**LIGO Project Modifications to the GS-13.  
LIGO E0900027-v1**

Brian Lantz, Mick Flanigan, Jeff Kissel, Brian O'Reilly  
Feb. 4, 2009

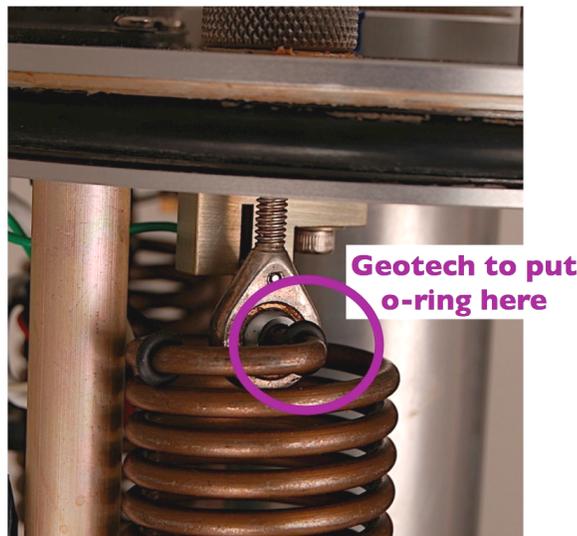
- a. remove Calibration Coil and the cap to which it is attached .
- b. remove Calibration Magnet
- c. remove the handle
- d. remove the front horizontal foot
- e. remove the rear horizontal foot assembly.
- f. remove adjustable feet  
(but leave the 3 vertical posts which the adjustable feet attach to)
- g. INSTALL a new viton o-ring, parker size 2-006 on each vertical offload spring  
these are available from McMaster Carr  
PN 1201T16

These are to be installed as shown in figure 2, around the spring, on the end near the top of the seismometer. LIGO personnel will slide the o-ring down so that it spans the gap between the first and second coil of the spring.
